JAMES PLACE ESTATES SUBDIVISION

APPLICATION NUMBER 5 DATE April 2, 2015

DETAIL SITE PLAN

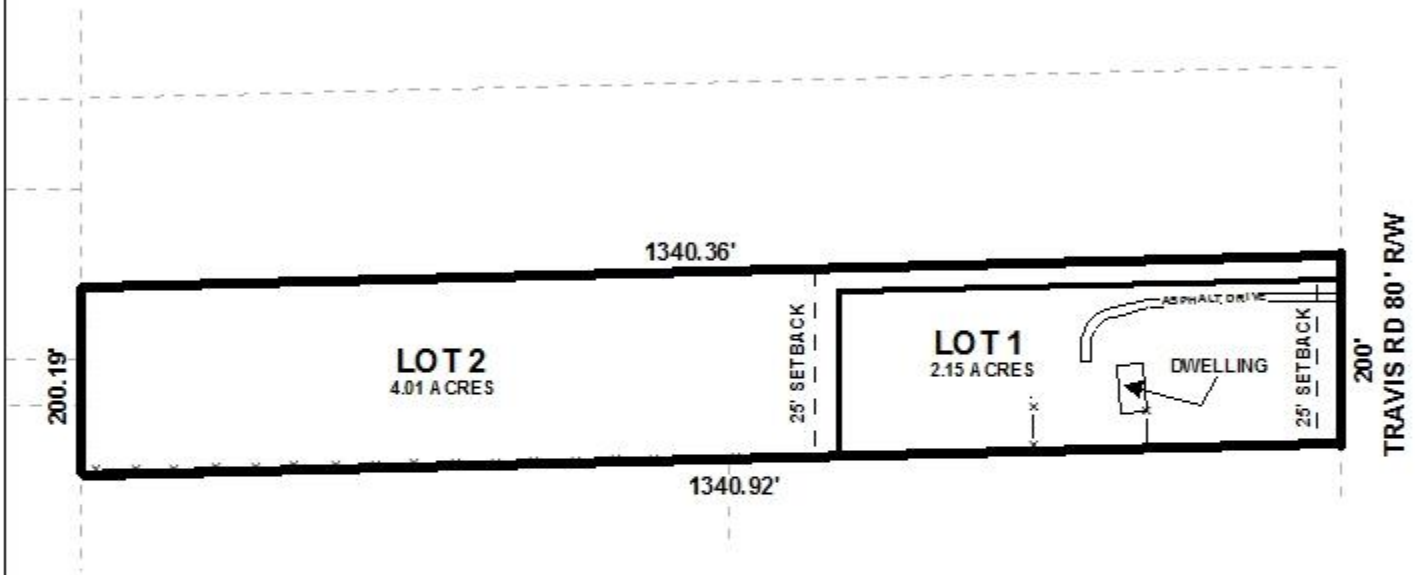
The proposed Lot 2 is a flag lot, and while meeting the minimum width of 25 feet for a flag lot, the applicant did not provide any information stating unusual circumstances may exist on the lot, if there is a natural or pre-existing man-made barrier which may cause an undue hardship, or if the proposed subdivision is a family subdivision. Flag lots are generally not allowed, and although there may be other flag lots within the vicinity, only two of those lots were approved by the Planning Commission prior to the 2008 amendments that prohibit flag lots.

It should be pointed out that while the proposed Lot 2 appears to have frontage to the west of the property to an unopened public right-of-way, the proposed layout of Lot 2 implies access only to Travis Road, thus should be considered a flag lot. The opening of the current unopened public right-of-way would allow access to Gunn Place Road for Lot 2; however, the opening of the public right-of-way is unlikely.

The proposed lots meet the minimum size and frontage requirements as regulated by Section V.D.2. of the Subdivision Regulations. However, Lot 2 does not comply with Section V.D.3. of

the Subdivision Regulations regarding the maximum width to depth ratio. Thus, a waiver of Section V.D.3 will be required in order to approve the subdivision as proposed.

As a means of access management, Lots 1 and 2 should be limited to one curb-cut each to Travis Road with the size, design, and location of the curb-cuts to be approved by Mobile County Engineering. Lot 2 should be denied access to Gunn Place Road until an improved compliant public road is provided to allow connectivity to Gunn Place Road.

The preliminary plat depicts the lot sizes in acres but not in square feet. The lots should be labeled with the sizes in square feet and acres on the Final Plat, or a table should be furnished providing the same information, if approved.

The 25' minimum building setback lines are depicted on the plat, except where Lot 2 abuts the unopened public right-of-way. If approved, the plat should be revised to include the depiction of the 25' minimum building setback line where Lot 2 abuts the unopened public right-of-way.

It should be noted, a waiver of Section V.D.8 regarding double frontage lots will be required for Lot 2, if approved.

Based on the preceding, the application is recommended for denial, for the following reasons:

- 1) the proposed Lot 2 does not comply with Section V.D.1. of the Subdivision Regulations regarding size and shape of lots, and no justification was provided;
- 2) the proposed Lot 2 does not comply with Section V.D.3. of the Subdivision Regulations regarding the maximum width to depth ratio;
- 3) there are currently no recent Planning Commission approved flag lots within the area, reflecting the flag-lot specific amendment of the Subdivision Regulations in 2008.
